PRIVATE WATER DISTRIBUTION SYSTEM IMPROVEMENTS

PRAIRIE HOMESTEAD

PROJECT NO. 1973PPW

AS BUILTS

TITLE SHEET

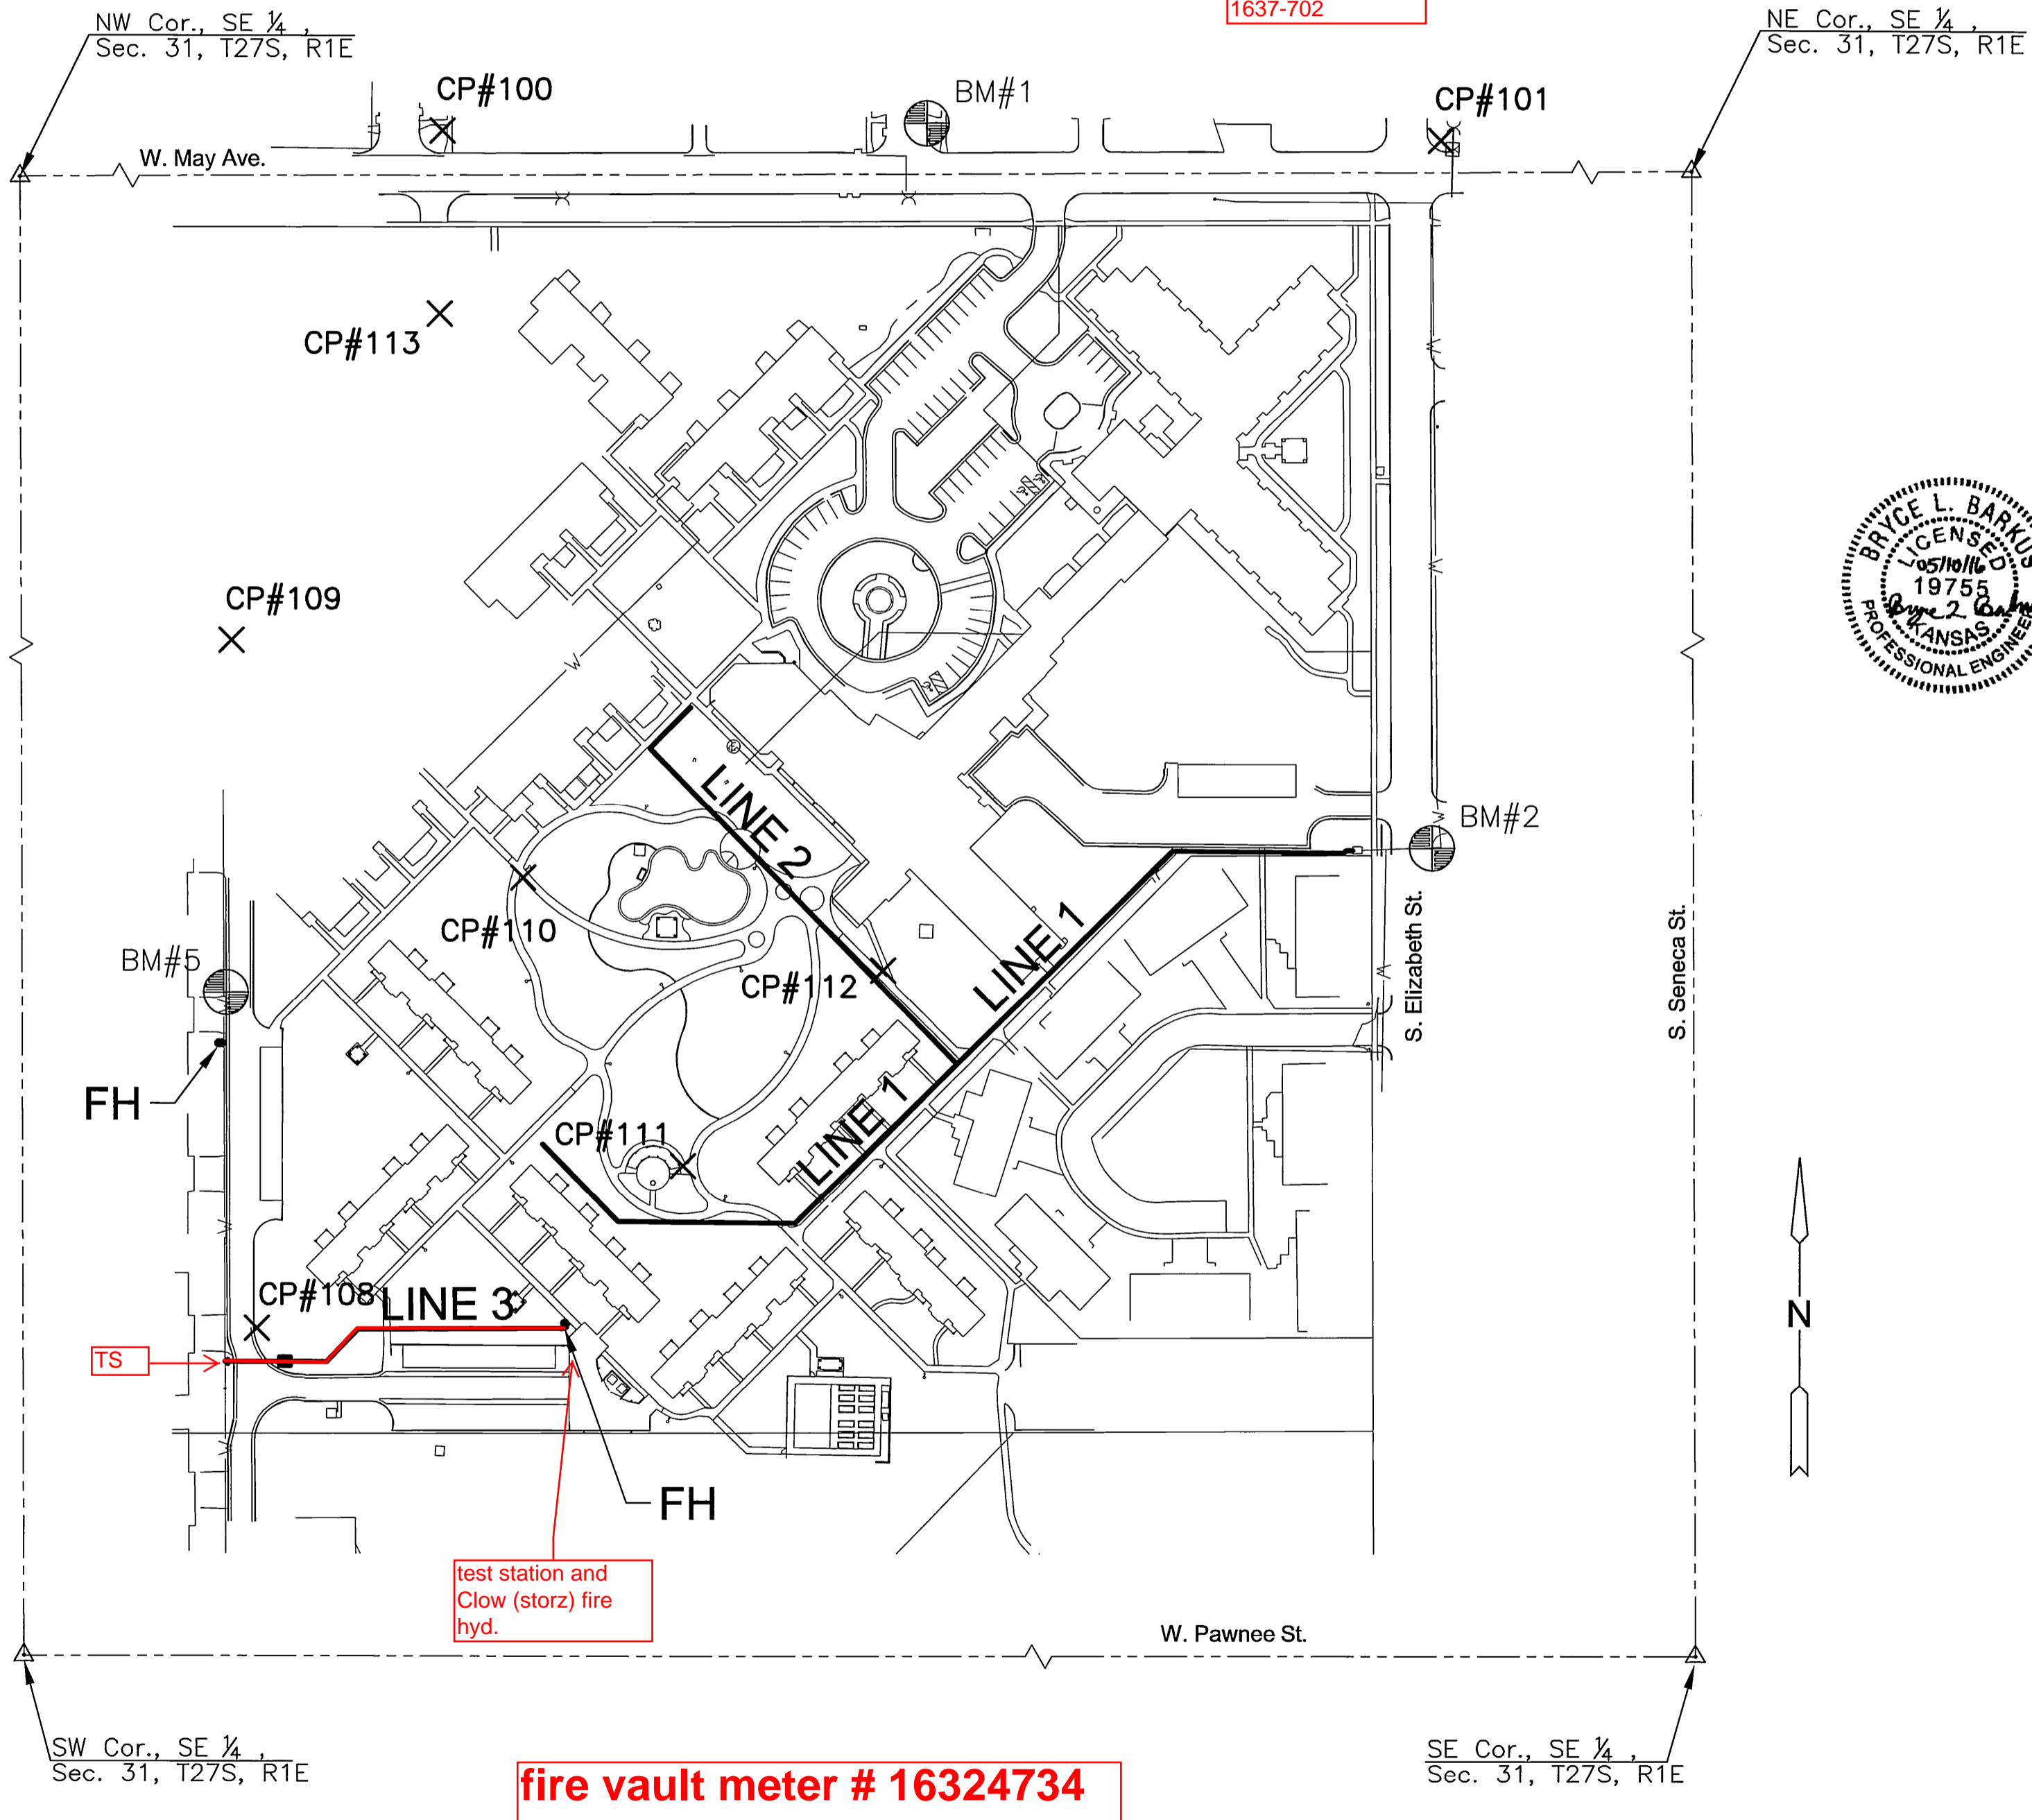
From building 1637-902 the existing fire hyd. North 20' to tapping sleeve and West 2' to valve

From same hydrant 260' North and 41 1/2' West to valve 2' West of valve to fire hydrant in front of building 1637-702

Northern C-900R
Vinylplex C-900
Sigma fittings
Pro-trace wire
Clow (storz) fire hydrant
Northern 3" Sch-40
260 psi

**WATER LINE 3 &
FIRE HYDRANT**

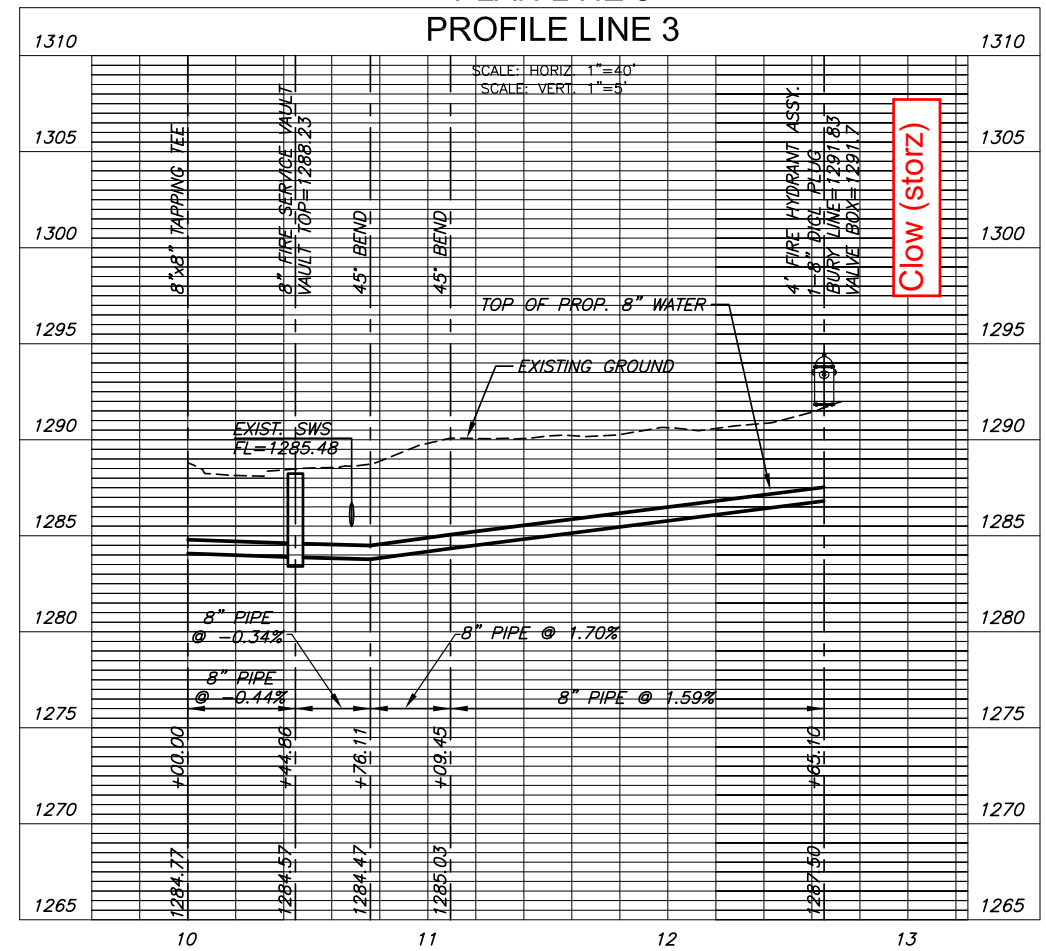
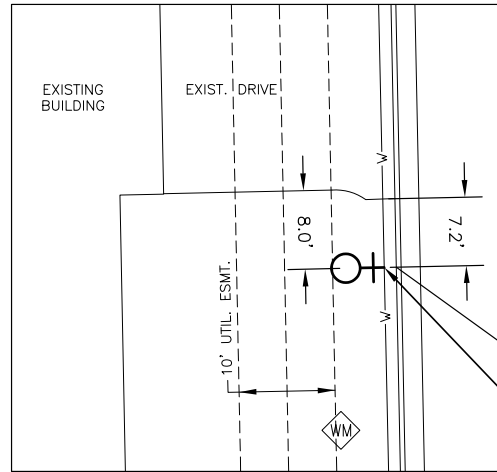
Test station

meter 160324735
000000.4

Test station and
Clow (storz) fire
hyd.

restrained pipe
directional bore

Clow (storz)
